ITS CORPORATION				REV	ECN	DATE	APV
TITLE				B/D			
				FRAME ASSEMBLY, 5700 SERIES			
DWN	MAS	10/29/97	DWG. NO.	REV			
CHK	RE	10/28/97	1585-3100	1			
REL	RE	10/29/97	C	SCALE 1=1 SHEET 1 OF 1

REV	ECO	DATE	APV	TITLE	DWG. NO.	REV
1	9526	10/13/98	BKW	SCHEMATIC, SINGLE STAGE AMPLIFIER (1585-1101)	1585-3101	1
REV	ECO	DATE	APV			
1	9526	10/13/98	BKW			
1	9526	10/13/98	BKW	SCALE 1=1	SHEET 10F1

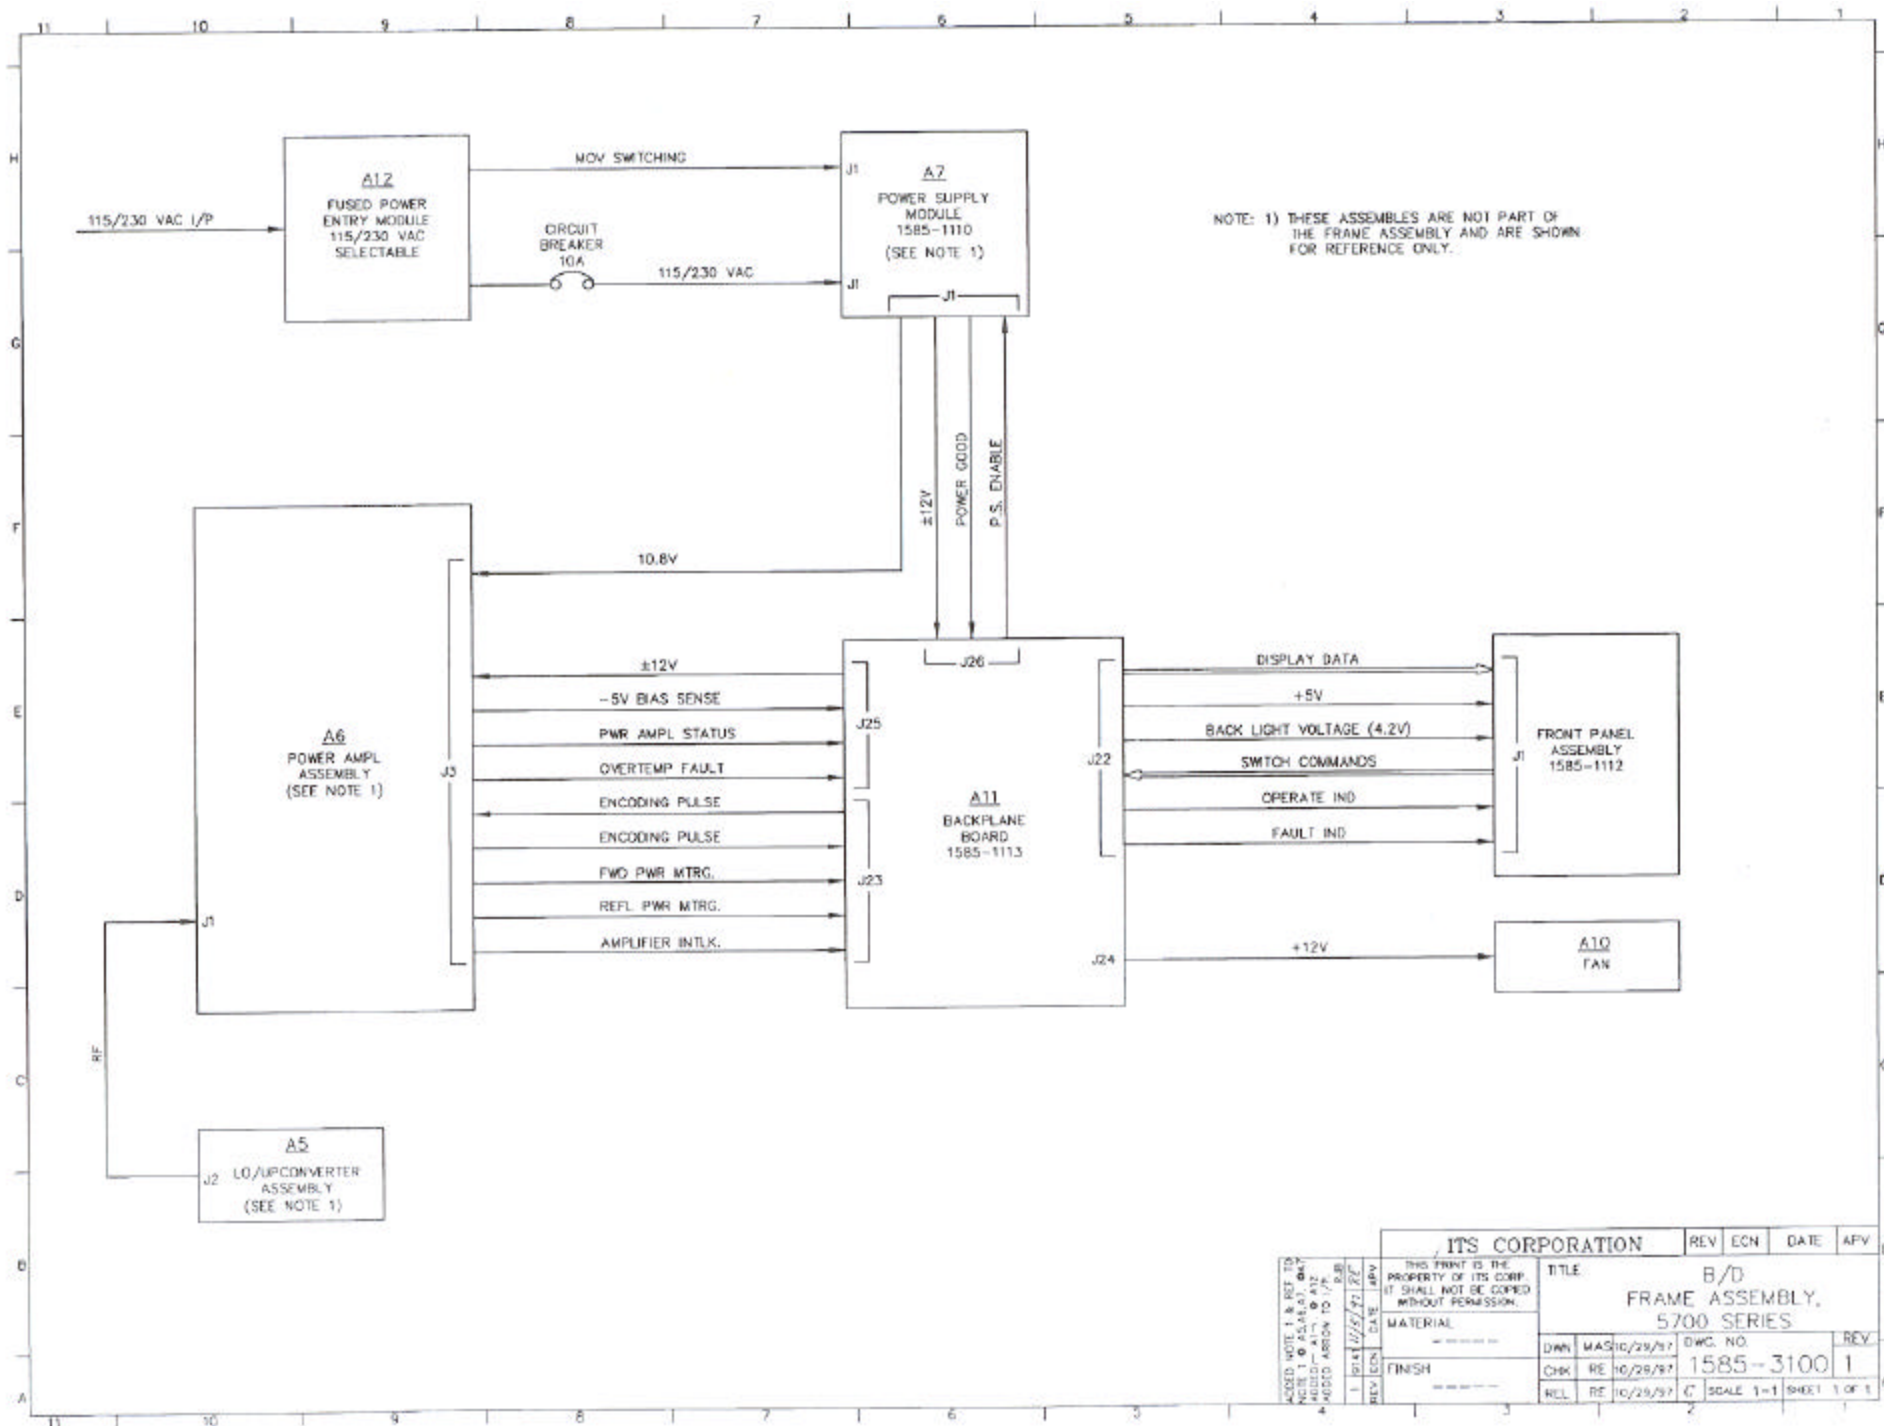
ADDED NOTE 1 & REF TO
NOTE 1 0 AS4640, 0A1
ADDED - A12
ADDED ADDN TO 1/2
1 10/11/97 JEC

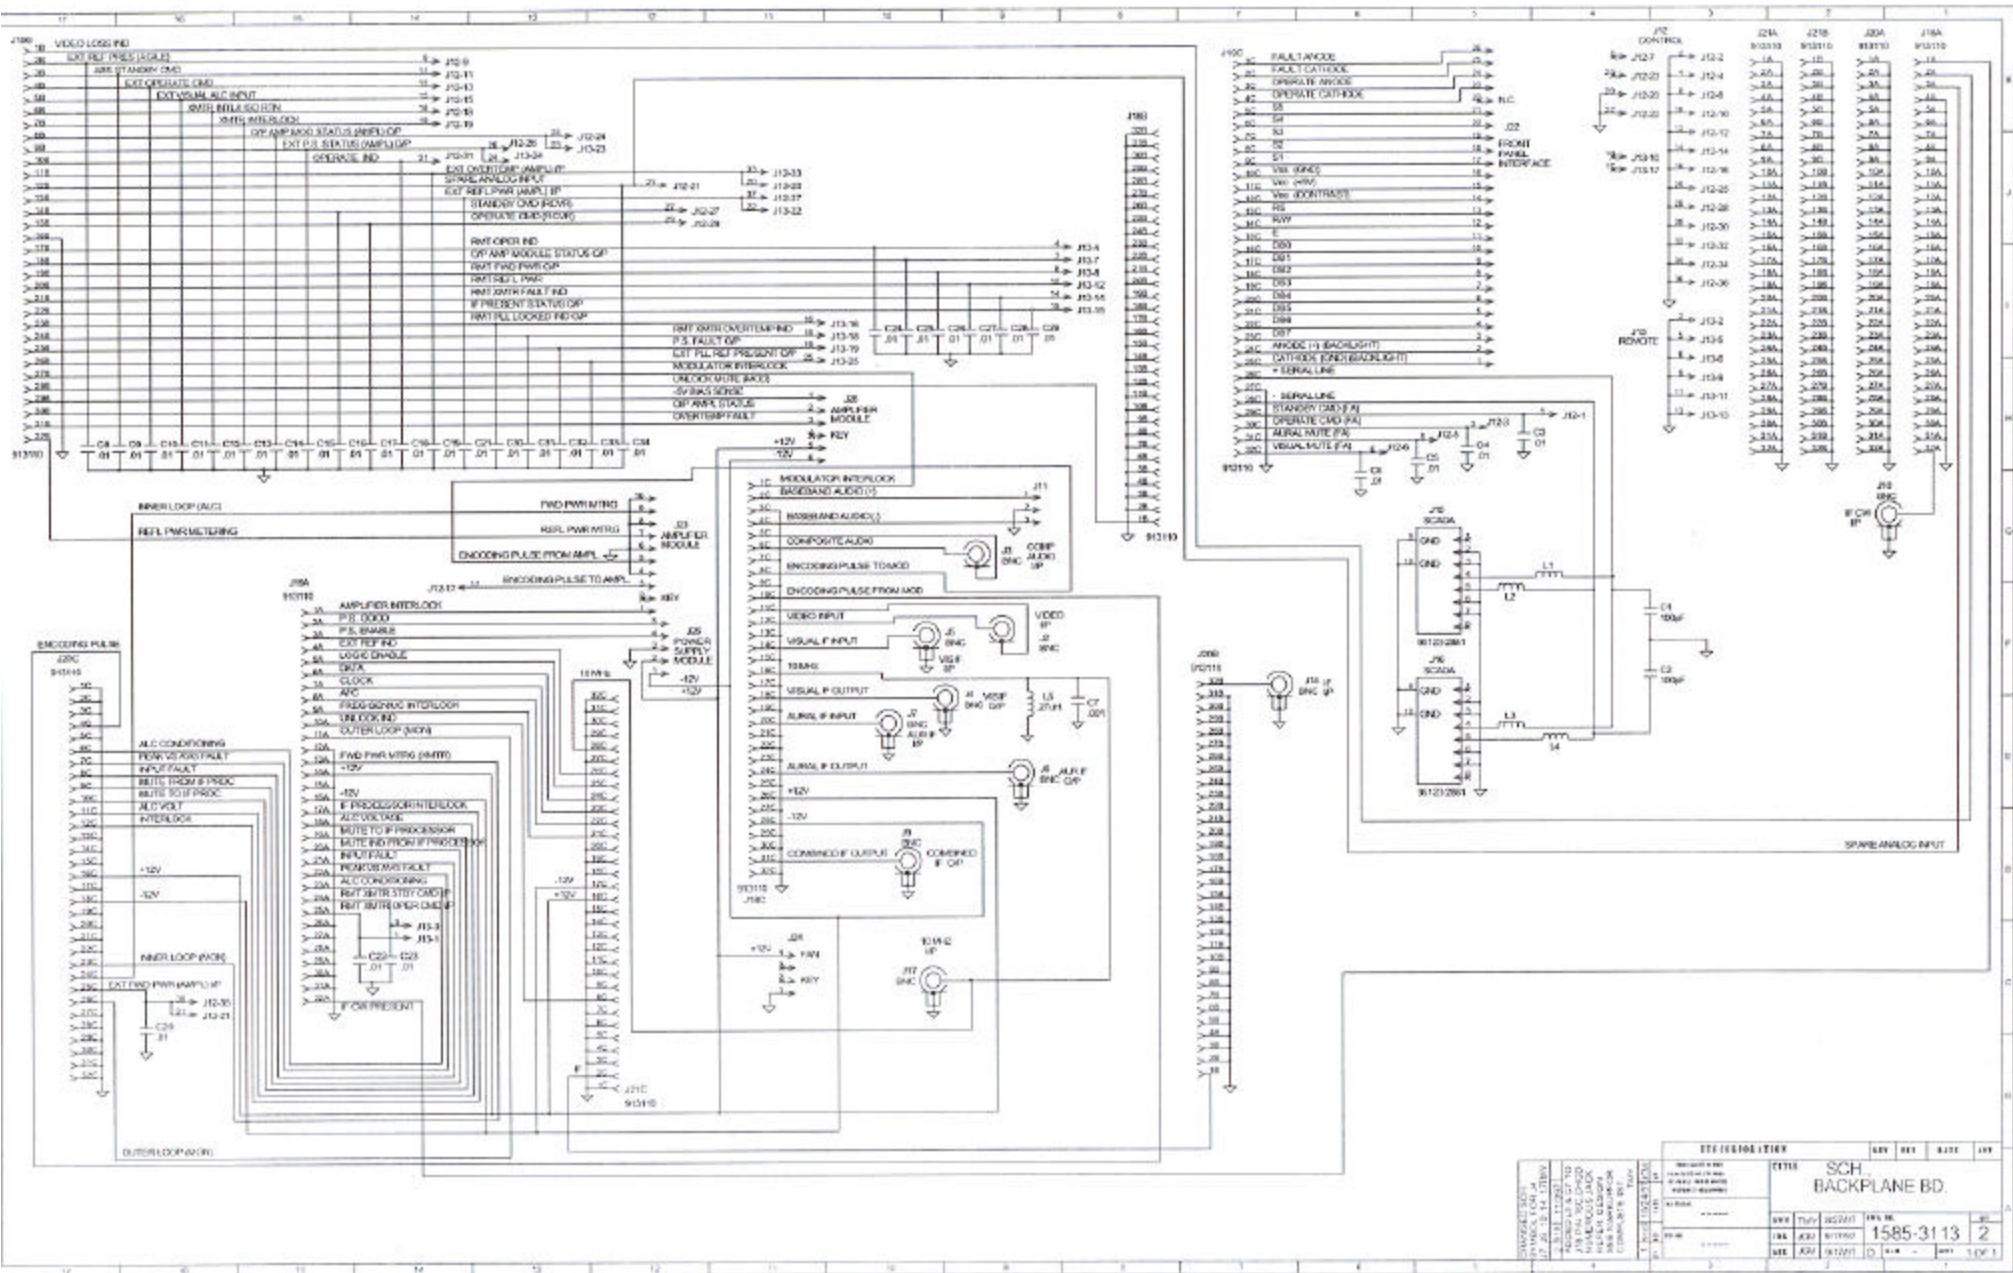
R2 WAS 18 OHMS. R1 & R3
WAS 300 OHMS. (RFB)

1585-3130	2
-----------	---

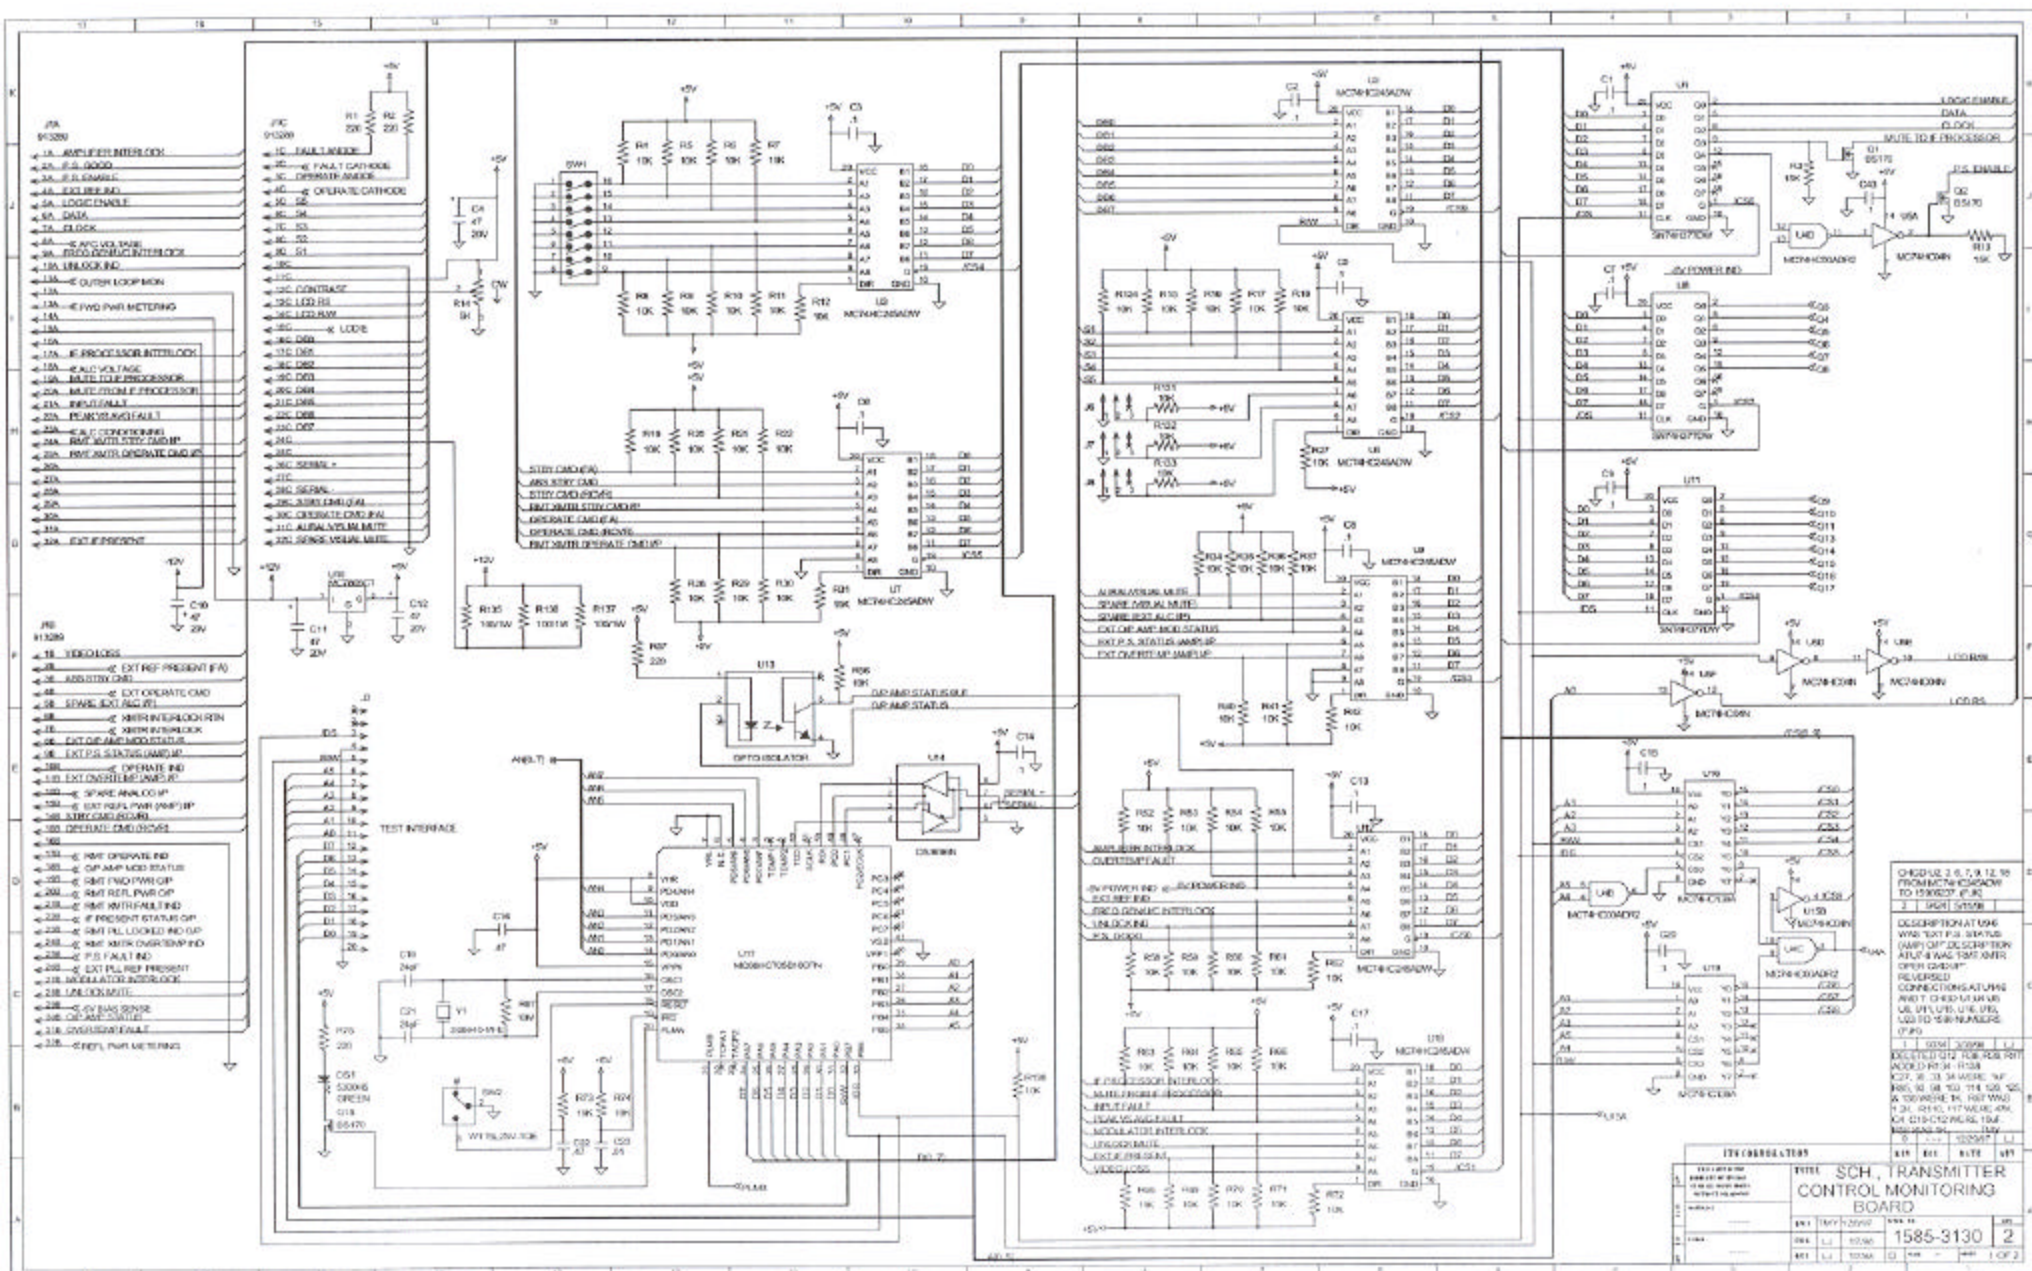
DESCRIPTION AT USE
WAS TEXT P.L. STATUS
(AWP) OFF. DESCRIPTION
AT U-4 WAS TEXT ENTER
ON CHRGD:
REVERSED
CONNECTIONS AT USE
AND T. CHRGD:U-4 USE
US, U-1, U-5, U-6, U-7,
U-8 TO 1500 NUMBERS
(FUR)

1	0344	2399	17
DECLUTED C12 FCB 928 901			
ADDED R734 - R738			
C27, 36, 33, 34 WERE 94F			
R85, 90, 98, 100, 114, 120, 125,			
& 126 WERE 14, 147 WAS			
1 24, 1240, 117 WERE 404,			
CH C19-C12 WERE 154F			
REMOVED 94, 1147			
0	0000	00000	11
